# Interim Status Change Number 2: Interim Status Groundwater Monitoring Plan for the 216-A-37-1 PUREX Plant Crib

**RCRA INTERIM STATUS GROUNDWATER MONITORING PLAN  
 INTERIM CHANGE FORM**

<b>Change Number:</b> <i>(Obtain Change Number From Interim Change Custodian)</i> RCRA-CN-02_DOE/RL-2010-92_R3	<b>Date:</b> 9/17/2020
---	---------------------------

<b>Document Number:</b> DOE/RL-2010-92	<b>Title:</b> Interim Status Change Number 2: Interim Status Groundwater Monitoring Plan for the 216-A-37-1 PUREX Plant Crib	<b>Rev:</b> 3
---	---	------------------

Table 3-1. Monitoring Well Network for the 216-A-37-1 Crib

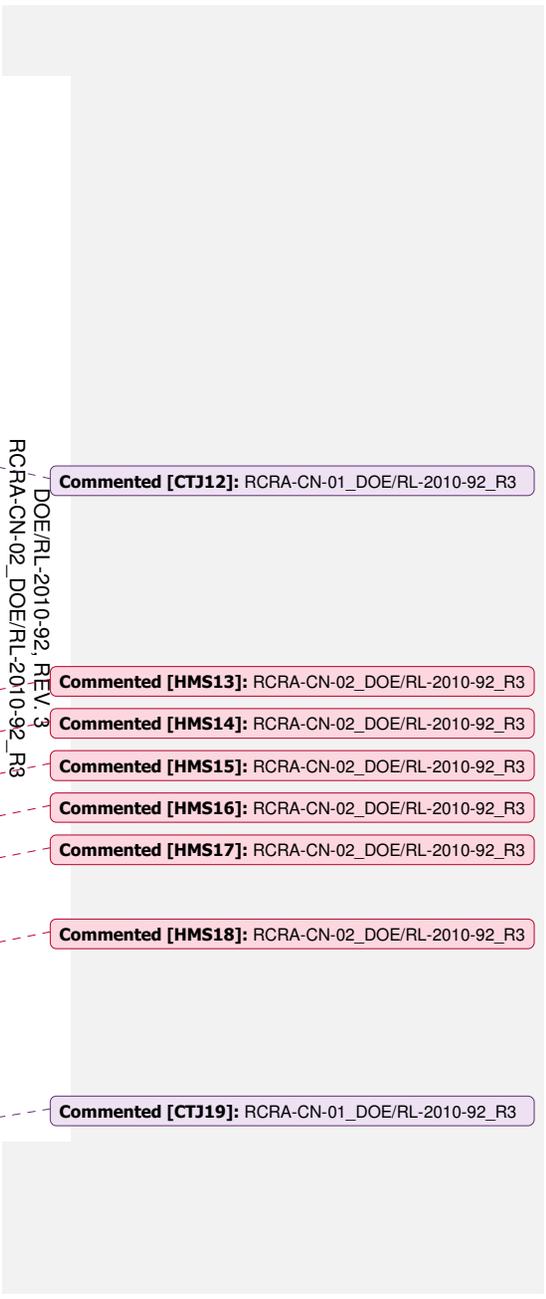
-In Tables 3-1 and 3-4, changed the sampling frequency for stainless steel corrosion constituents (chromium, iron, manganese, molybdenum, and nickel), and water chemistry analysis (alkalinity, anions [fluoride, nitrate, and nitrite], calcium, magnesium, and potassium) from annual to semiannual.

Commented [HMS18]: RCRA-CN-02\_DOE/RL-2010-92\_R3

-The sampling frequency for stainless steel corrosion constituents, water chemistry analysis, and anions was changed to semiannual to align with the frequency for collection of contamination indicator parameters.
